# Appendix J

## Noise Specialist Response

14 January 2016

**Regarding:** Rix's Creek Extension Project Submissions

**Figure 1: 90th Percentile Noise Contours – Day ( $L_{Aeq}$ , 15minute dB)**

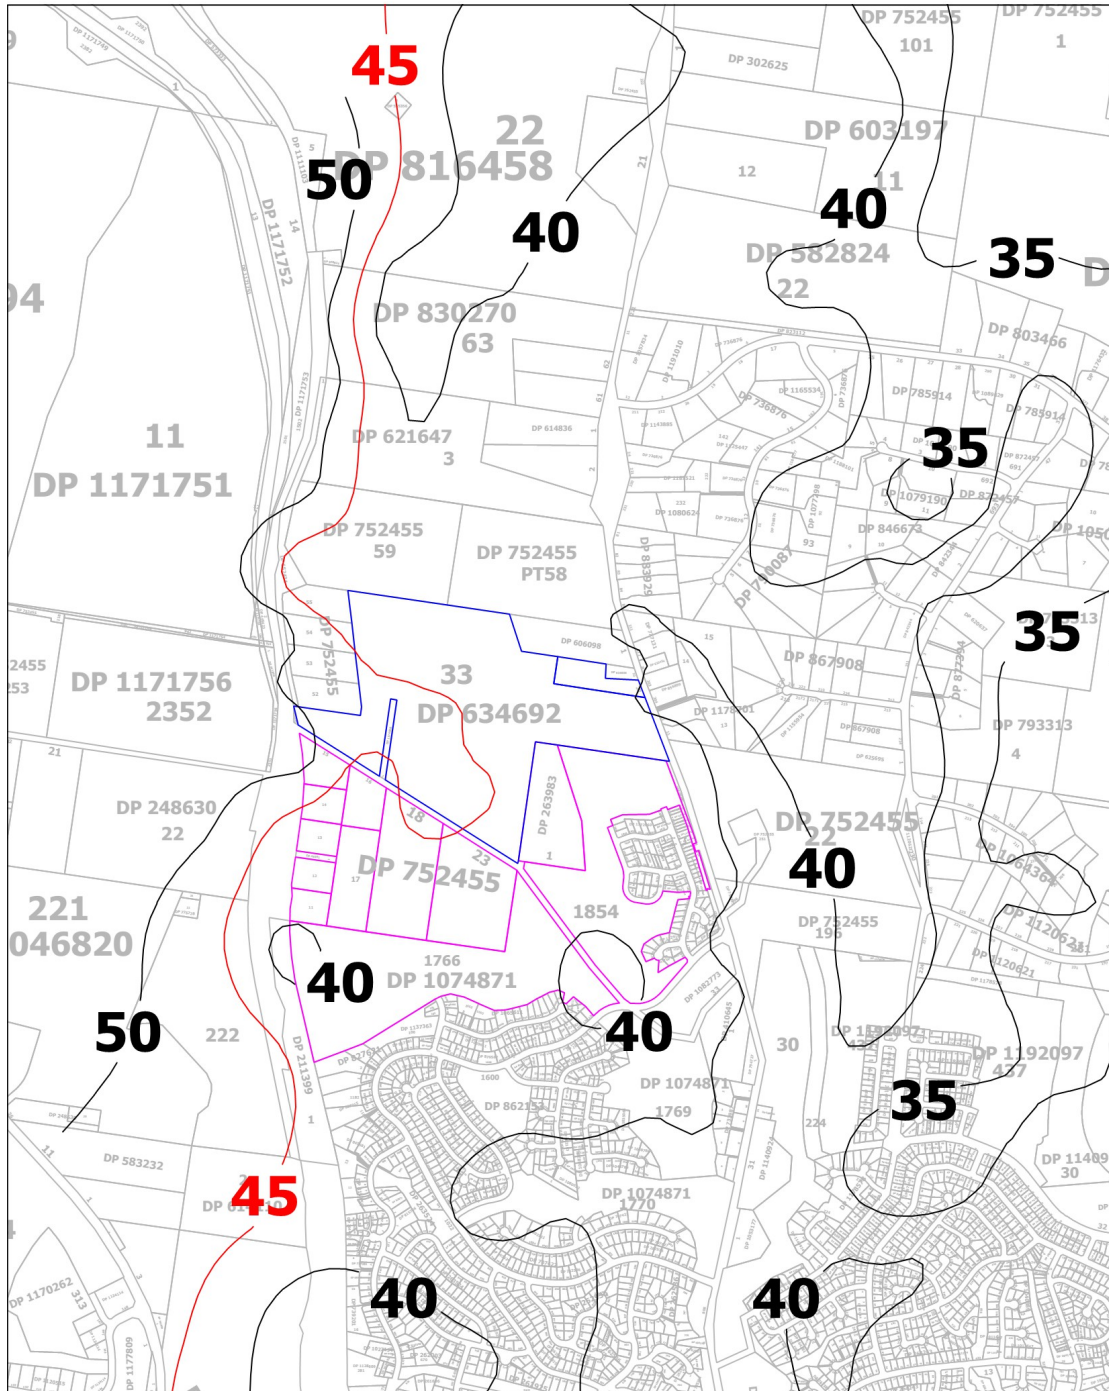
1. Future use of the subject lots as residential land has not been considered;
2. The western part of the subject lots are not included within any Noise Assessment Group (NAG); and
3. The submission seeks assurance that the proposed expansion of the mine and continued operation will not result in unlawful noise impacts on the subject lots.

1. Whilst not specifically included in the original vacant land assessment, the subject lots were included in the acoustic assessment by generating noise contours over the lot areas. This approach is standard practice for assessing vacant areas, as there are not currently individual residences to predict levels to. To improve the accuracy of the noise contours in the area, the models have been reprocessed with a higher density of receiver points over the subject lots. Updated noise contours over the subject lots and an assessment against Voluntary Land Acquisition and Mitigation Policy criteria are included in Attachment A.

Where applicable, contours indicating recommended maximum noise levels from Table 2.1 of the INP are highlighted red. These are used to provide an assessment of vacant land impact in accordance with the Voluntary Land Acquisition and Mitigation Policy (VLAMP). Further detail is contained in Section 3.3.2 of the ENA.
